35/13-06Q 12 East Lenox St
Chevy Chase Village Historic District, 35/13

HISTORIC PRESERVATION COMMISSION STAFF REPORT

PROPOSAL: Landscape alterations and patio installation

SUBJECT: Historic Area Work Permit # 419011 for Landscape Alterations and Patio Installation

Tree Survey
12 East Lenox Street
Chevy Chase, MD

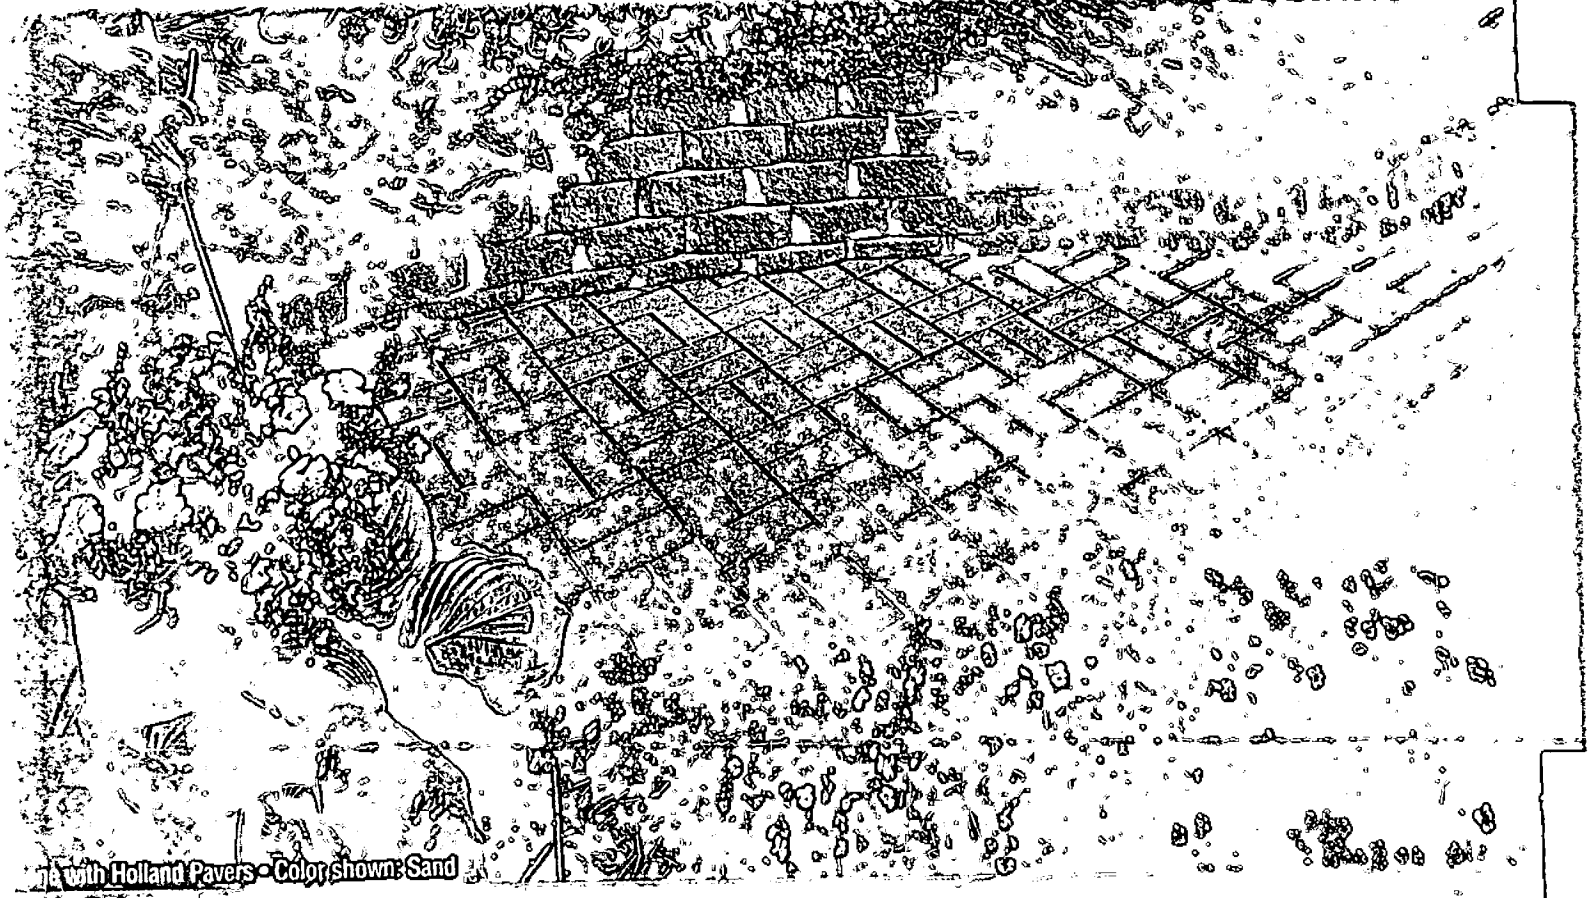
The applicant will continue to work with the Chevy Chase Village arborist to develop the tree protection plan for this project. This plan will be implemented prior to any work beginning on the property.

The proposed construction of a patio and retaining wall on our property is within the dripline of one tree – a 48” White Oak on our adjoining neighbor’s property (Campbell; 12 East Kirke Street).

We have been in contact with Shana Davis-Cook, Chevy Chase Village’s Manager of Administration, and Bill Dunn, the Chevy Chase Village arborist. We plan to implement all of the tree protection measures they recommend for this project.
